## 2.7 Cable data [Editor's note: Tom Cloonan, ARRIS]

### 2.8 Optical Transport Network [Editor’s note: Xi Huang, Huawei]

Figure 18—Bandwidth related terms

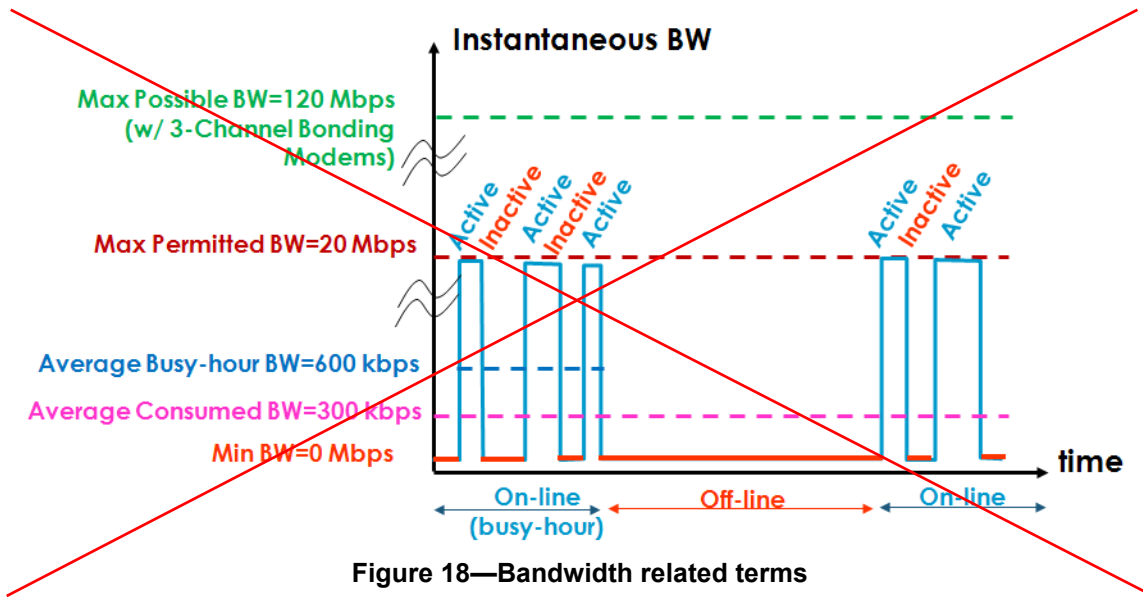
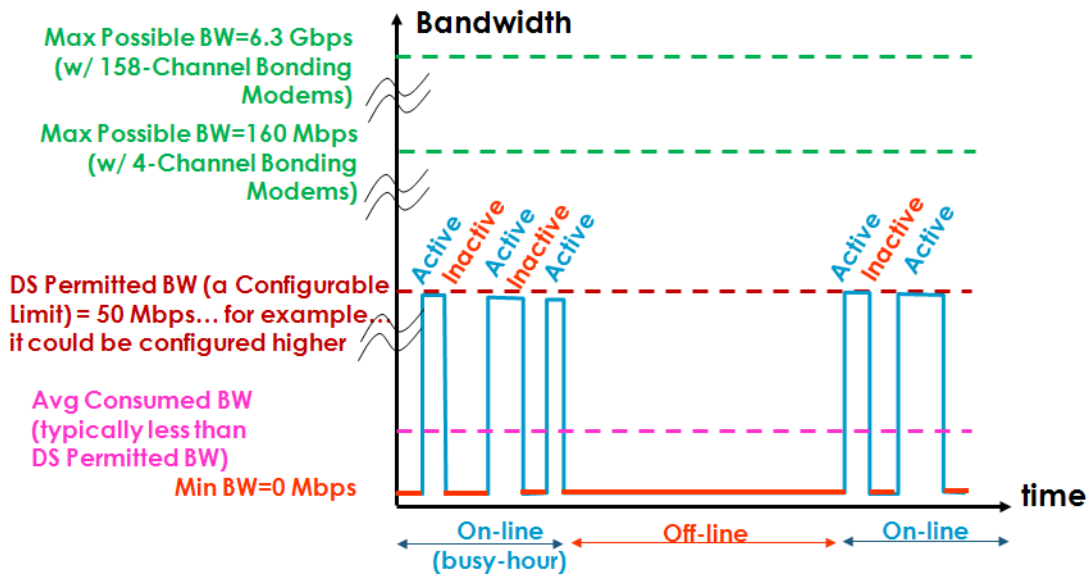
Where the average busy-hour bandwidth and the The average consumed bandwidth are is used quite extensively for traffic engineering calculations (determining how much capacity is required to satisfy a given Service Group (pool) of subscribers).

Figure 21—Maximum permitted upstream bandwidth trend

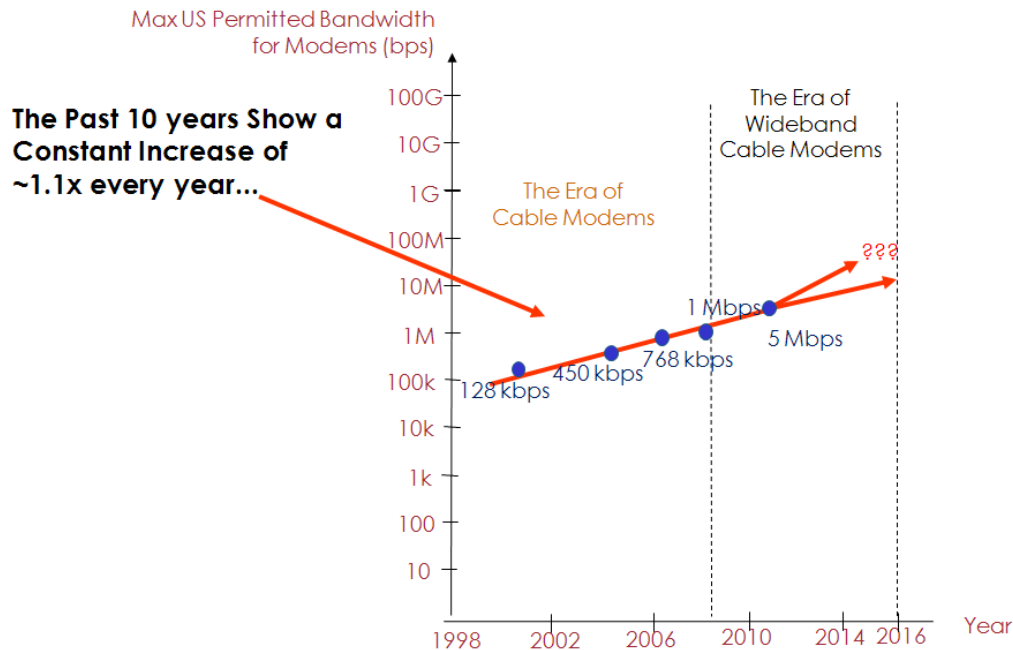
Data for the maximum permitted upstream bandwidth over time is plotted in Figure 21 [9]. This plot (which is on a logarithmic vertical scale) shows a roughly constant rate of increase in maximum permitted upstream bandwidth of about 1.1 times per year. ~~However, recent activity suggests an accelerating rate of increase.~~ Upstream bandwidth is comprised of two types of traffic: protocol messages (e.g., HTTP GETs, TCP ACKs, etc.) and uploads (e.g., P2P torrents, web page inputs, FTP transfers). The protocol message bandwidth is predictable [9] and so it should increase in line with the rate of downstream bandwidth increase. The upload

bandwidth is harder to predict [9] as it is highly dependent on the popularity of apps at any given time. For example when P2P ~~was big~~ represented a large percentage of the traffic in 2008, upstream bandwidth was ~41% of downstream bandwidth. However, when over the top IP video became ~~big~~ popular in 2010, upstream bandwidth dropped to be only ~28% of downstream bandwidth.

If the maximum permitted upstream bandwidth ~~is assumed trend continues~~ to be one fifth of the maximum permitted downstream bandwidth [9] grow at a 10% CAGR, then it would be expected rise to ~608 Mb/s by 2016. ~~Also~~ However, if the average indicators are that this upstream bandwidth of 73 kb/s in 2010 ~~is assumed to trend could~~ grow by at a factor of 1.5 times per year much faster rate in line with average downstream bandwidth [9], then it would be expected rise to ~0.8 Mb/s by 2016 the next four years.

Figure 23—Downstream bandwidth trends in 2010

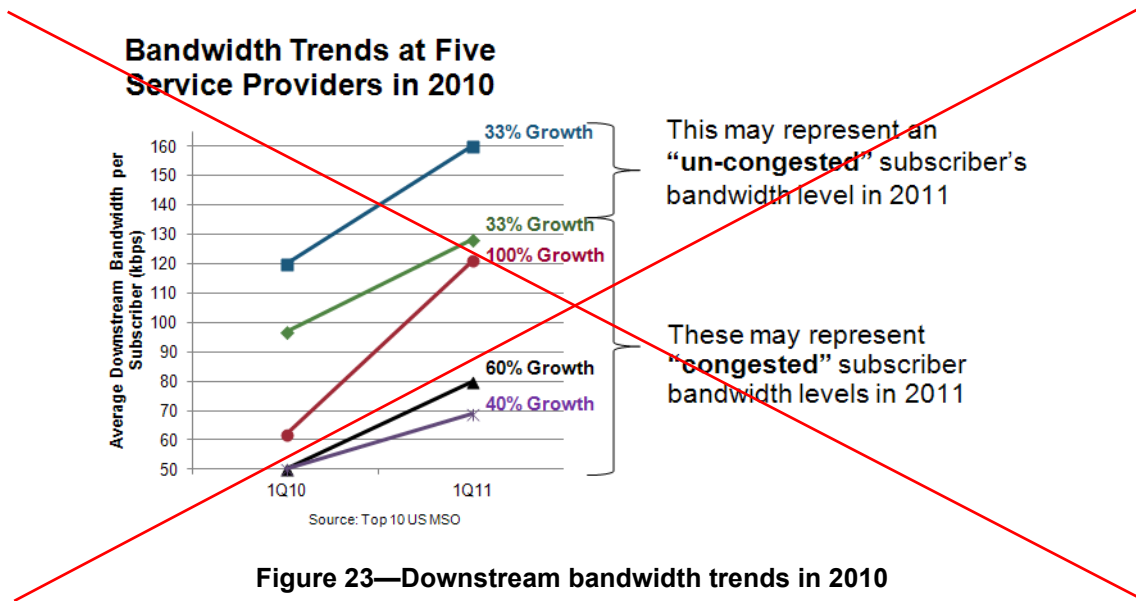
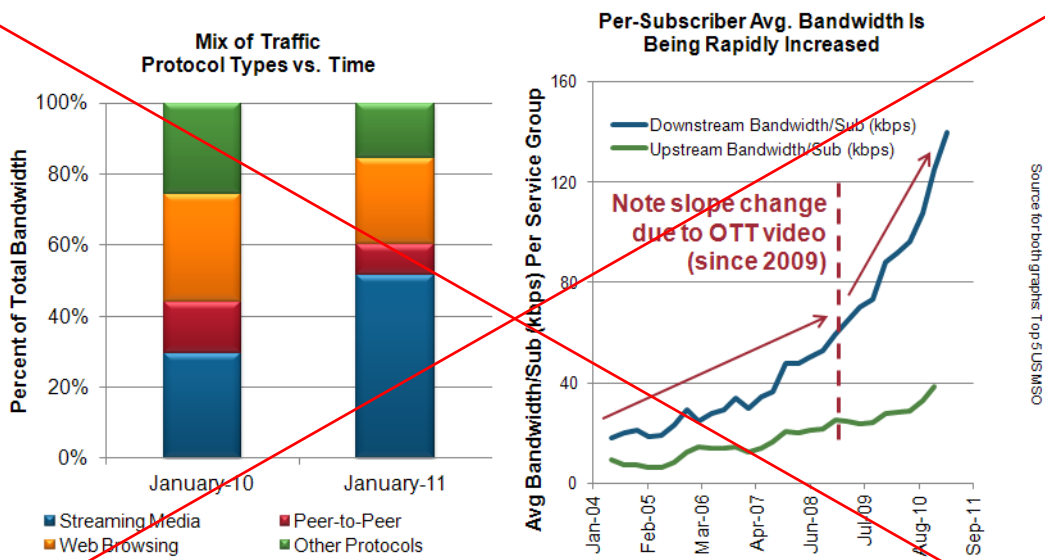
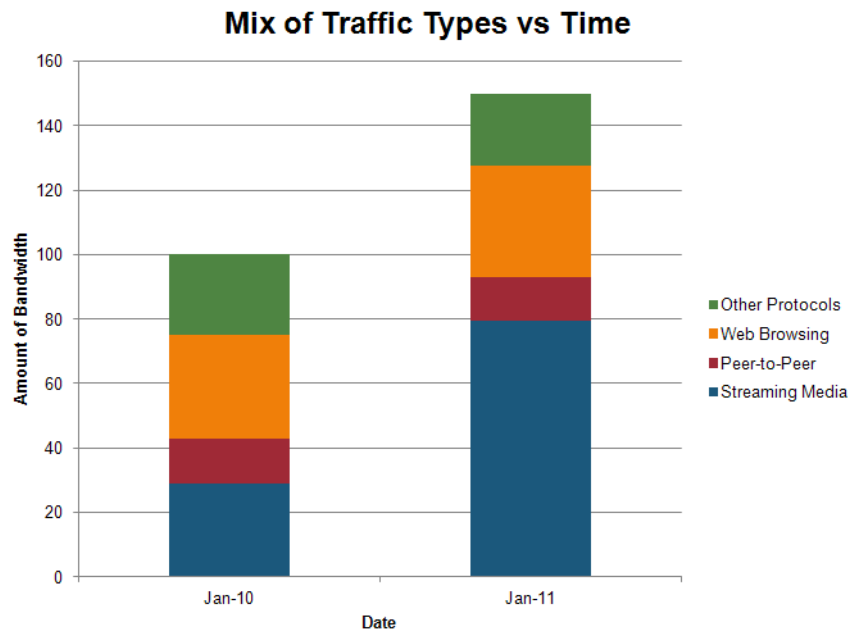
~~In the period since 2009, there has been a rapid uptake of over the top IP video which has cause a change in slope of the downstream bandwidth per subscriber curve [9]. See Figure 23.~~

In the period since 2009, there has been a rapid uptake of over-the-top IP video which has helped drive the continual increase in downstream consumption that is shown in Figure 20. This transition has also changed the mix of traffic types carried over the cable networks. These changes can be clearly viewed within Figure 23.
